14-H-15
43-45 Turner Street
Hagge Residence
Cyns Hagge

**CITY OF PORTLAND, MAINE
DEVELOPMENT REVIEW APPLICATION
PLANNING DEPARTMENT PROCESSING FORM
Planning Copy**

Hagge Residence
Project Name/Description

43 - 45 Turner St, Portland, Maine
Address of Proposed Site

RESIDENCE 45 TURNER ST.
ELEVATION
FRONT ELEVATION

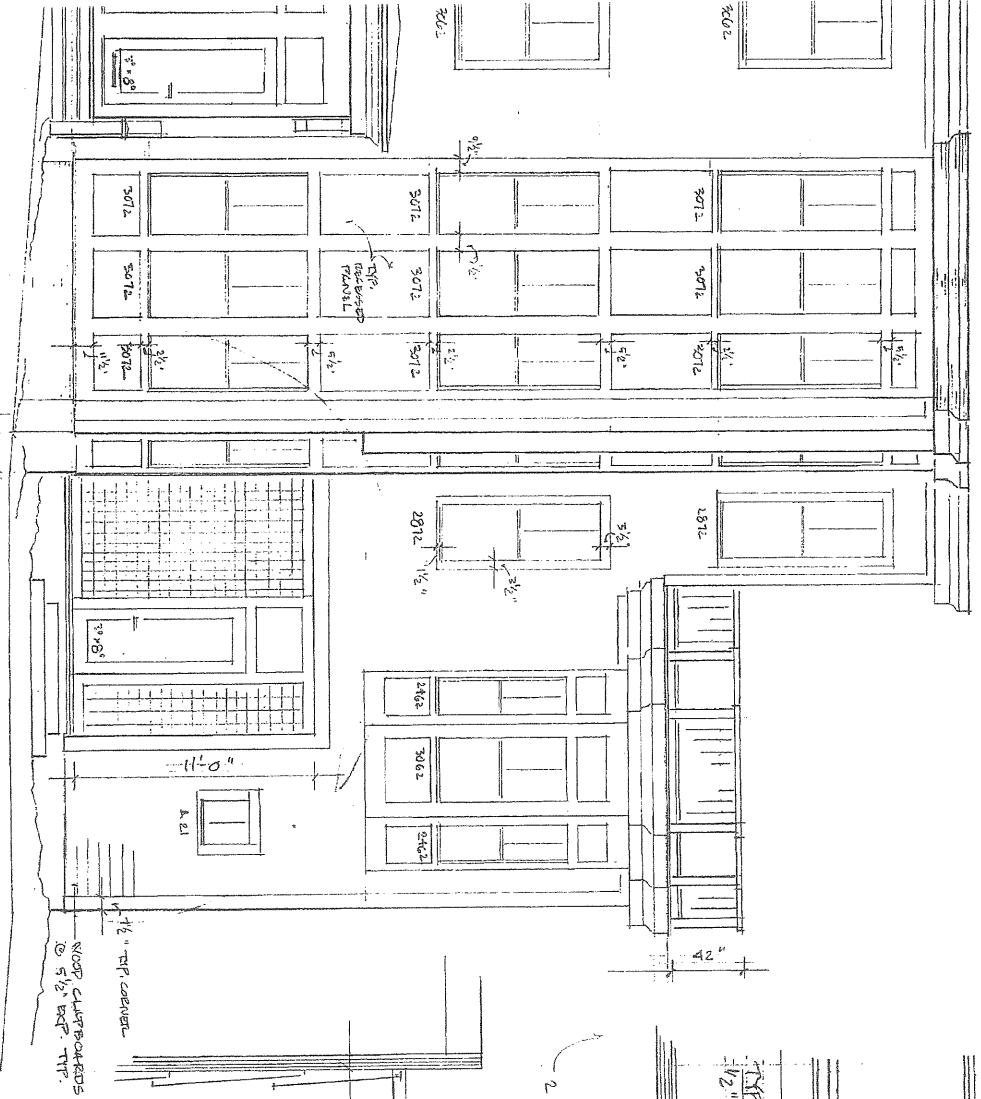
Barbara, The developer of the Turner St. duplex (Cyrus Hagge) has made some revisions to the facade of the building. Phil has taken some pictures of the completed facade and Cyrus has submitted some facade plans of the changes. Apparently he is nearing a c of o request.

The most significant change is a curvilinear glass block field adjacent to the secondary entrance to the building. The primary part of the building is built to the street line (with an entrance) but a secondary wing of the building is set back about 45 from the street.
